**Proposal #08: 2718-20-70**  
**Prairie Avenue**  
**Bridge over Fox River B-67-0177**  
**Local Street**  
**Waukesha County**

This is Addendum No. 01, which provides for the following:

**ADDENDUM NO. 01**

**2718-20-70**

Addendum No. 01  
 ID 2718-20-70  
 Revised Sheet 5  
 February 16, 2021

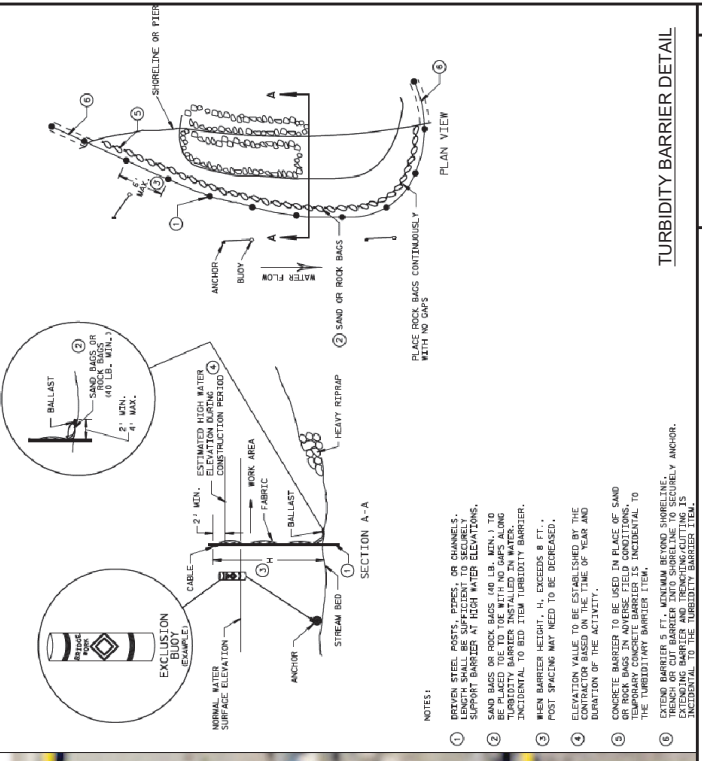
<b>Revised Plan Sheets</b>	
Plan Sheet	Plan Sheet Title (brief description of changes to sheet)
5	Erosion Control (Revised geometry of riprap, removed silt fence, added turbidity barrier, and added Turbidity Barrier Detail)
8	Miscellaneous Quantities (Removed Silt Fence and Silt Fence Maintenance, and added Turbidity Barrier)
30	Structure B-67-177 Concrete Overlay (Revised geometry of riprap)

TURBIDITY BARRIER DETAIL

**Addendum No. 01**  
**ID 2718-20-70**  
**Revised Sheet 30**  
**February 16, 2021**

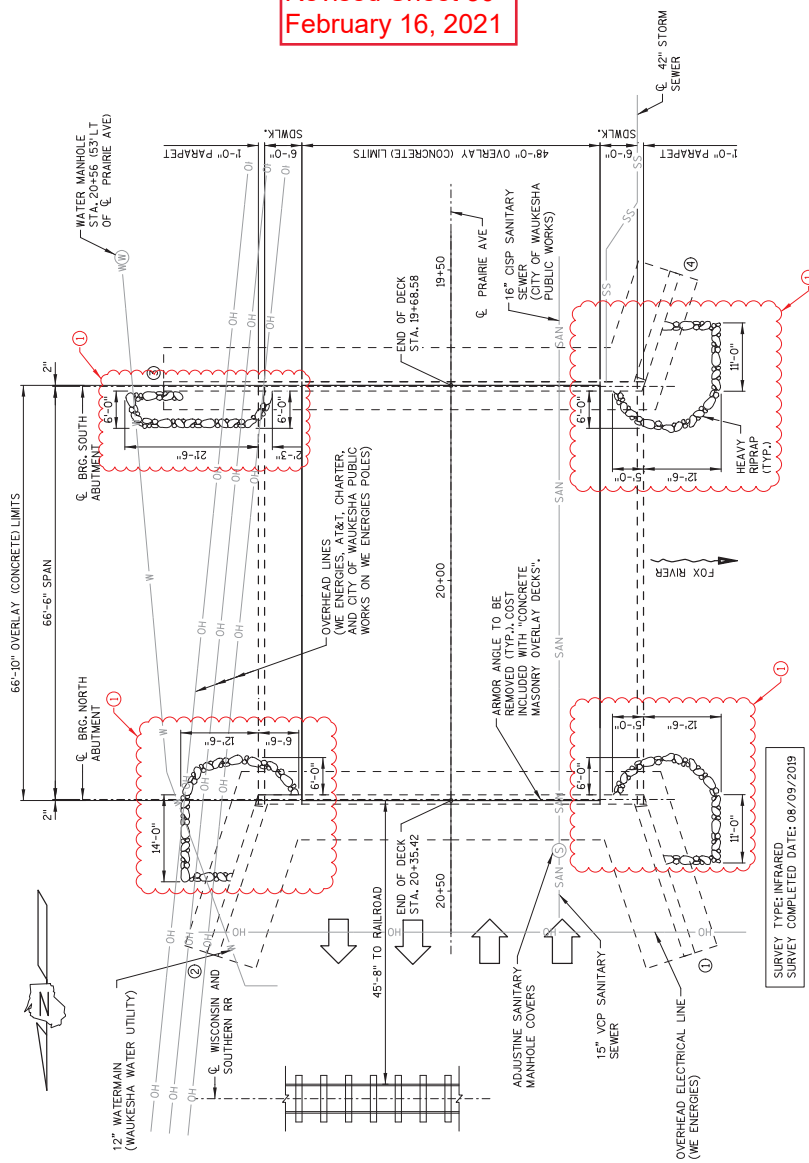
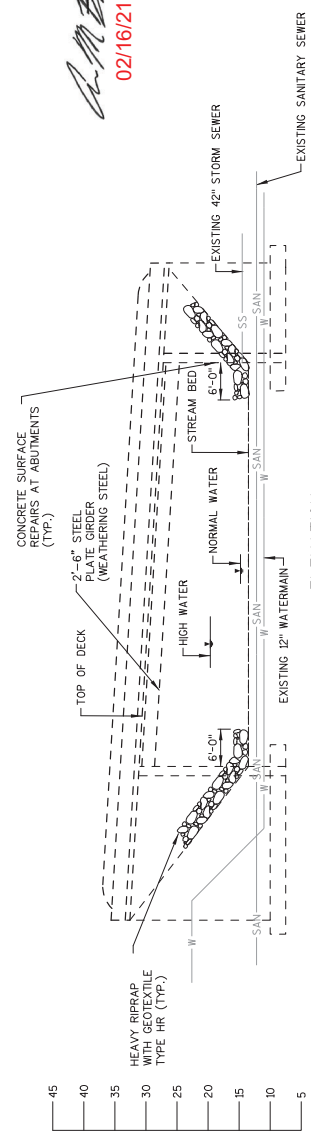
NO.	DATE	REVISION	BY
1	2/02/21	R/RAP UPDATES	CEB
